To: Miles Orlopp, LLFA engineer
From: Caroline Jeanne SLR /
Jeremy Collins GGP
Company: Suffolk County Council
SLR Consulting Limited
cc:
Date: 28 February 2024
Project No. 405.064987.0007

RE: Spring Grove Farm
Lead Local Flood Authority (LLFA) Response

Thank you for your letter in response to the Flood Risk Assessment (FRA) and Surface Water Drainage Strategy (SWDS) (SLR Ref: 404.11923.00004.0005 Version No:1 dated August 2023) for the proposed Anaerobic Digestion Plant at Spring Grove Farm, Withersfield, Northwest of Haverhill, Suffolk, CB9 7SW (the 'Site'). This Technical Memorandum aims to address the objection to the proposed development at the Site regarding the surface water drainage strategy as set out in your email dated 17th October 2023.

Drawing Title: **Drainage Plan**

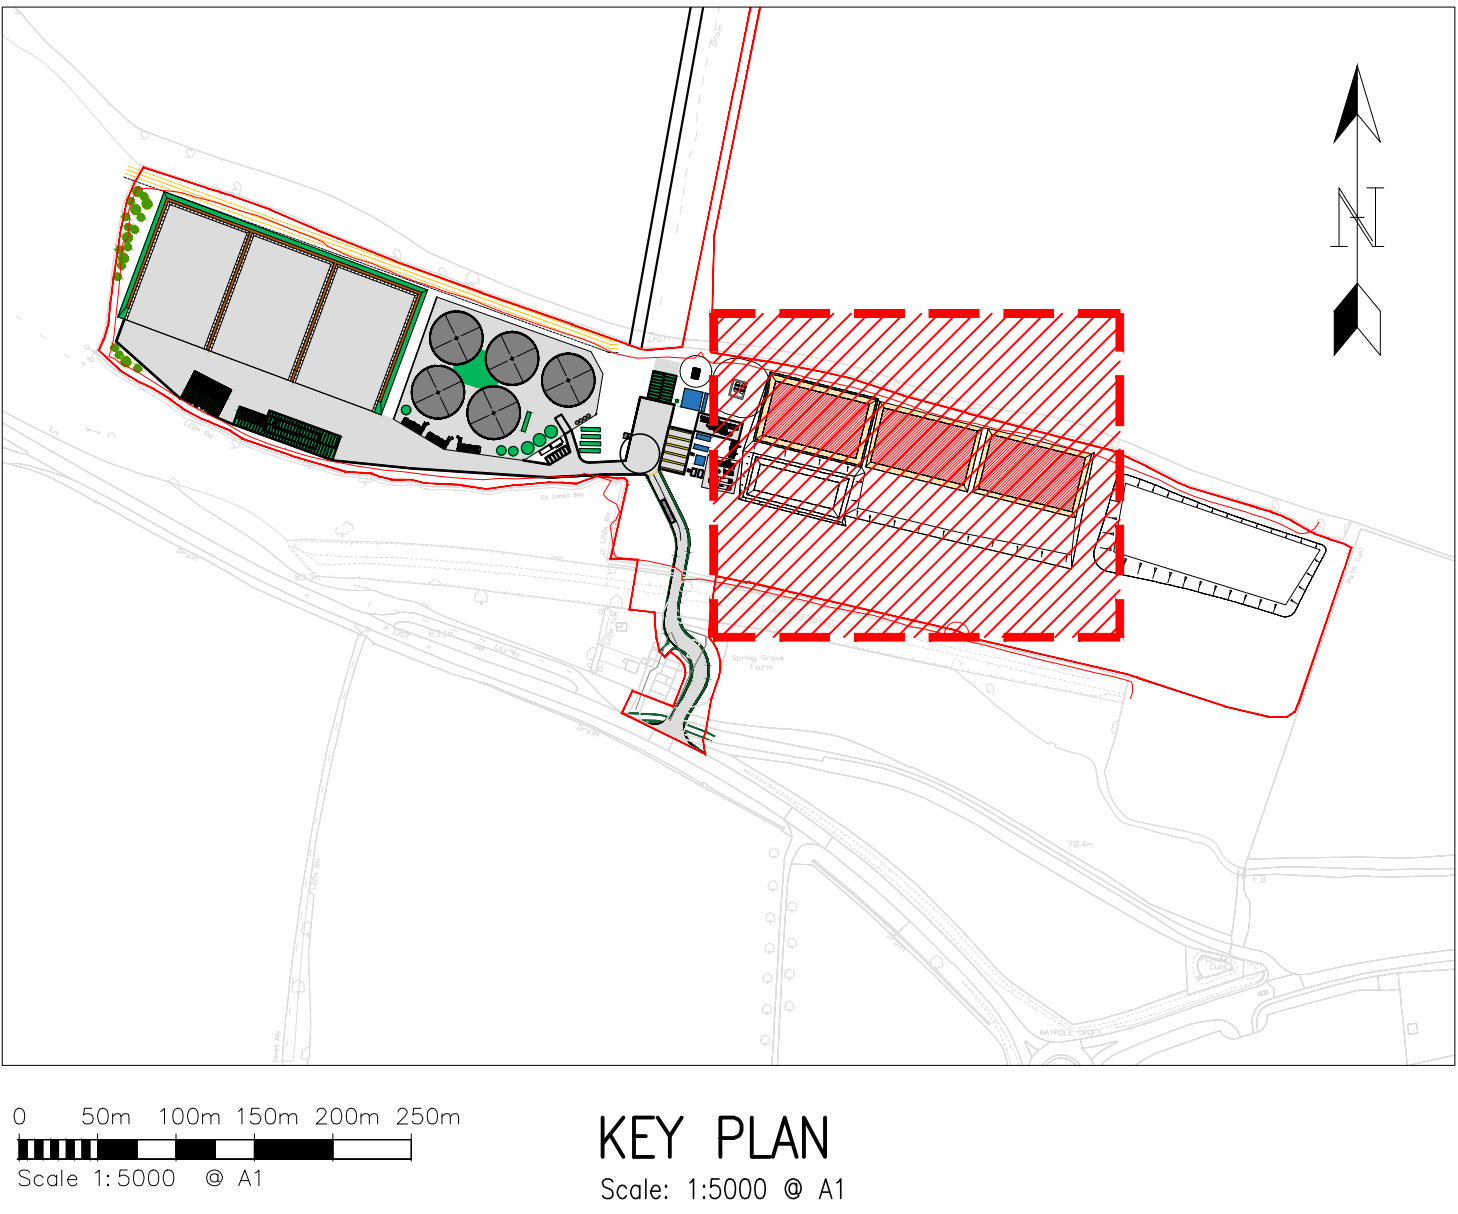
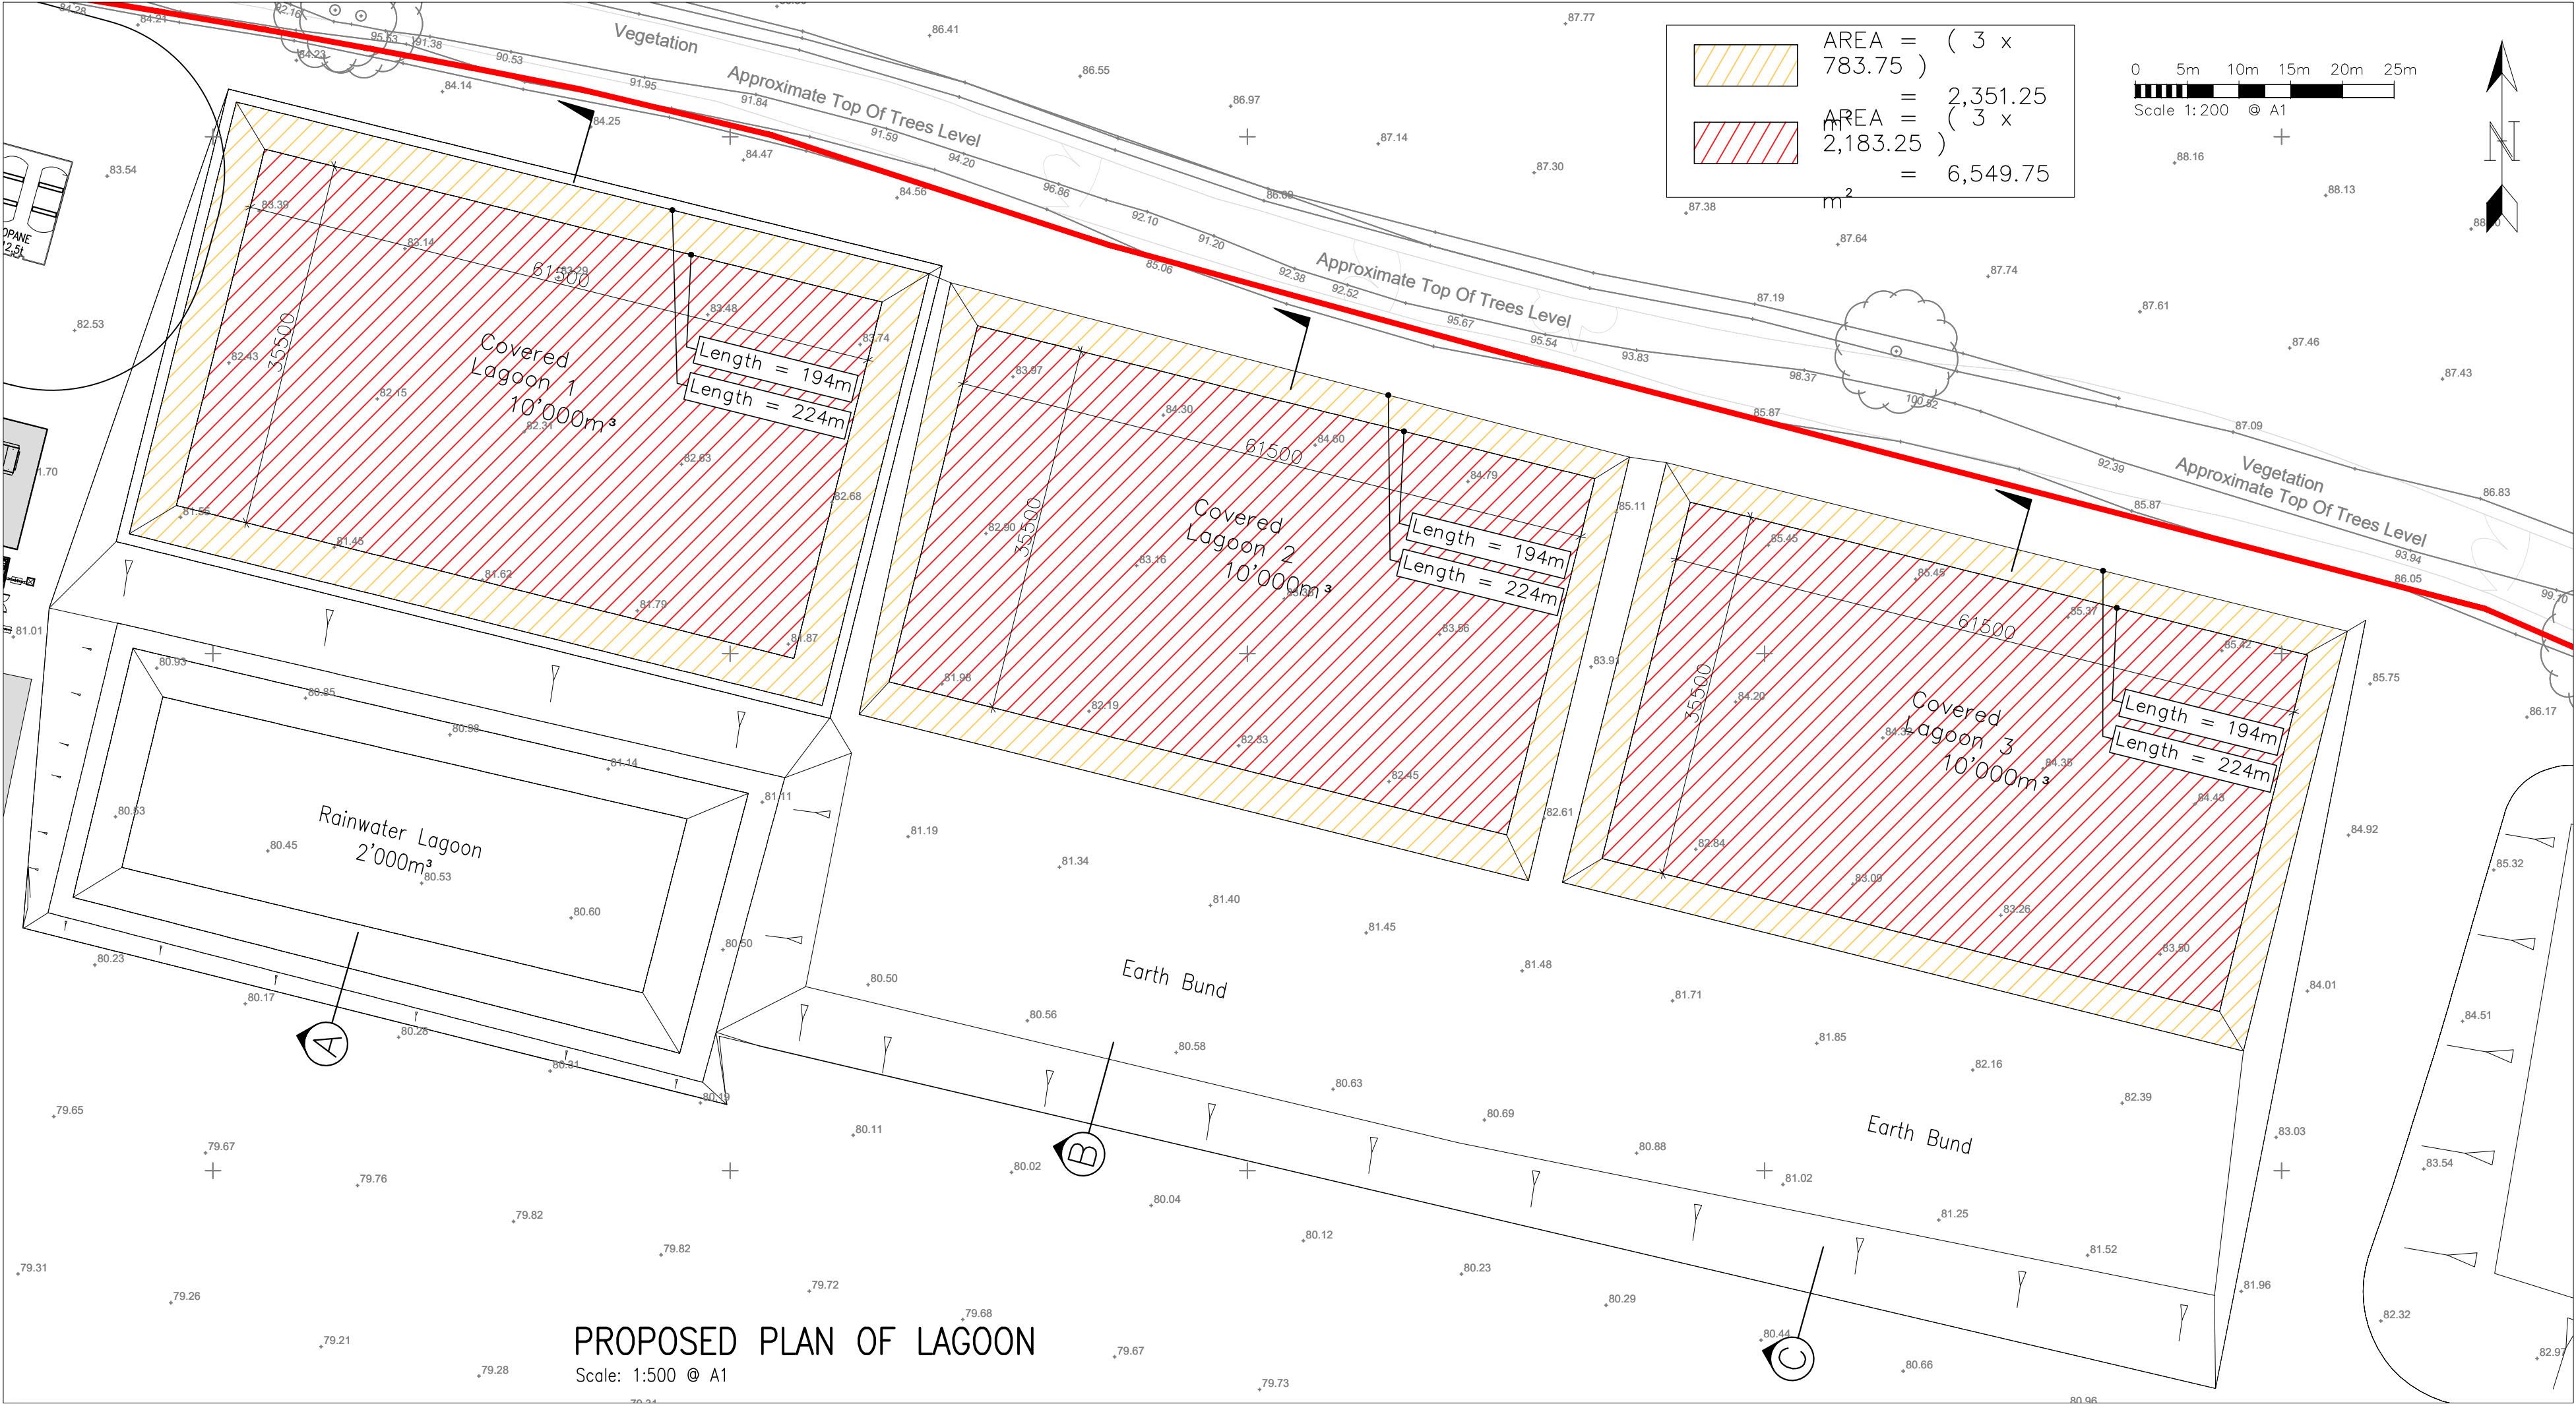
"Detailed SuDS drawings will need to be included within the drainage strategy, i.e., cross, and long sectional drawings. All features should be designed in accordance with Suffolk SuDS Guidance. We also expect to see a contour plan, exceedance routes and impermeable area drawings included within the drainage strategy".

As discussed in our meeting, the detailed SuDS drawings for the proposed development are included within **Appendix 01** as follows:

- GGP-29351-P-105-C Drainage Plan;
- GGP-29351-P-121-C Proposed Lagoon Details;
- GGP-29351-P-105a-C-Drainage Catchment Plan.
